13577-CRH-Alderholt-20230524.docx

ALDERHOLT MEADOWS - P/OUT/2023/01166

We write in respect to your letter 3rd April in which you objected to the Flood Risk Assessment (FRA) and Drainage Strategy submitted in support of the above application.

Figure 4.5: Surface Water Catchment Areas

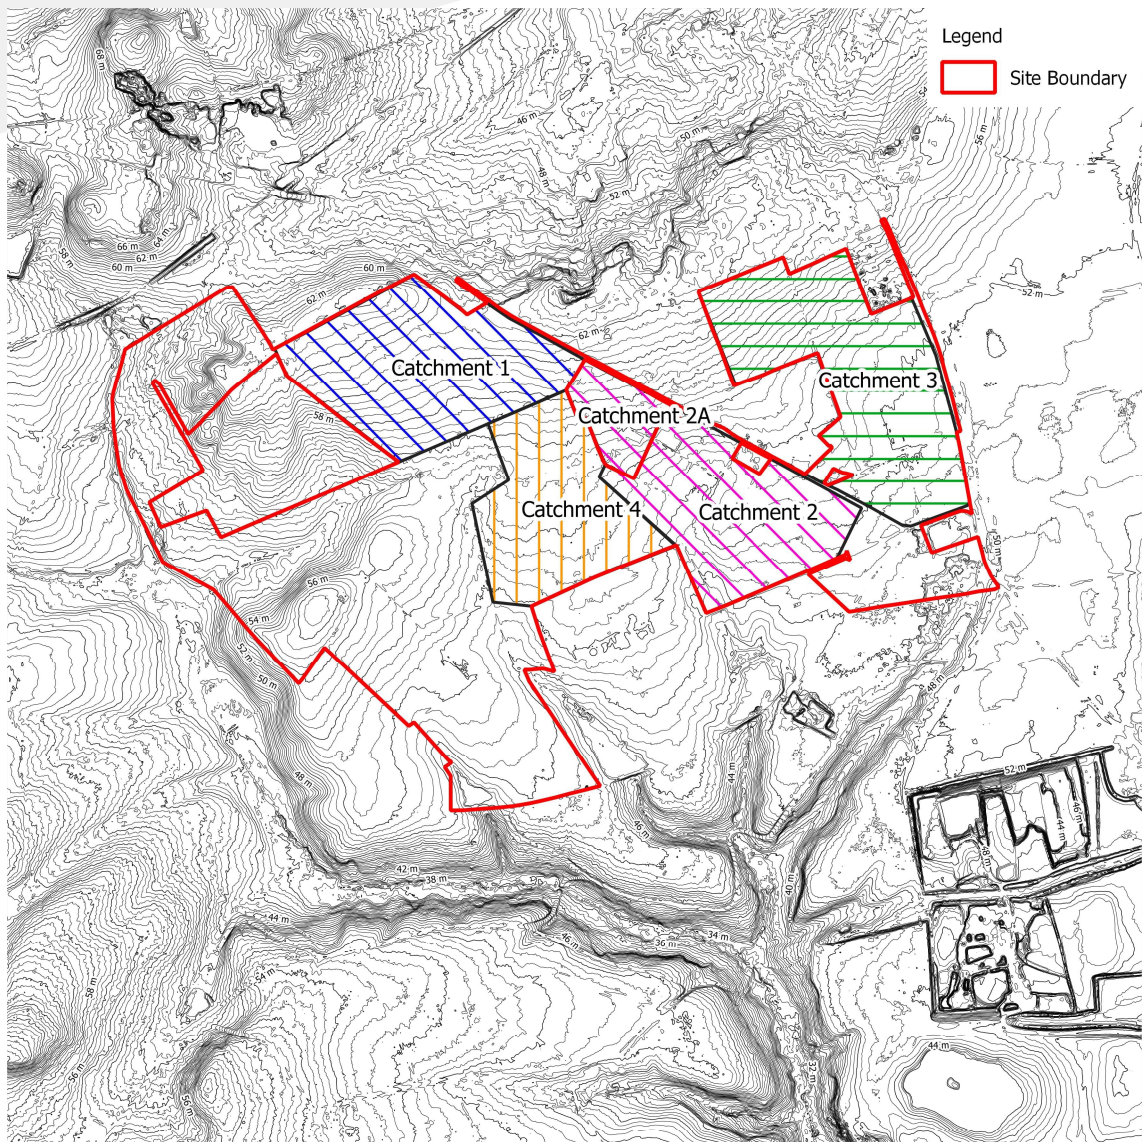
Item 1 – As discussed, we cannot be expected to attenuate flows from third party land, and as such, the pass forward rates from these catchments will need to be assessed and agreed with yourselves to ensure there is no detrimental impact on the proposed development surface water drainage system, refer to Section 7.5.6.

Item 2 – Table 4.1 has been updated to include the greenfield run-off rates in litres/Sec/ha. The greenfield run-off for the site is approximately 8 l/s/ha. The greenfield runoff rates were calculated using the FEH method and appropriate soil characteristics for the site.

Catchment	Area (ha)	Greenfield Runoff Rate (litres/sec/ha)	Greenfield Runoff Rate (litres/sec)		
		Qbar	1 in 1 year	1 in 30 year	1 in 100 year
1	17.0	8.20	118.7	321.1	445.4
2 & 2a	14.0 + 3.5	8.14	96.9 + 24.2	262.2 + 65.5	363.6 + 90.91
3	17.0	8.07	116.6	315.5	437.6
4	13.0	8.28	91.5	247.5	343.2

- 7.5.6. Flows from Catchment 2a are proposed to pass through The Site unrestricted maintaining the current status quo. Pass forward flow rates to be agreed with the LLFA.
- 7.5.7. The proposed surface water drainage system can effectively control all runoff generated within The Site and maintain pre-development greenfield runoff, without increasing flood risk elsewhere. The proposed surface water drainage strategy is contained in Appendix F.
- 7.5.8. The maintenance of SuDS is vital ensuring that they work as efficiently as they set out to do and is discussed in Chapter 9.
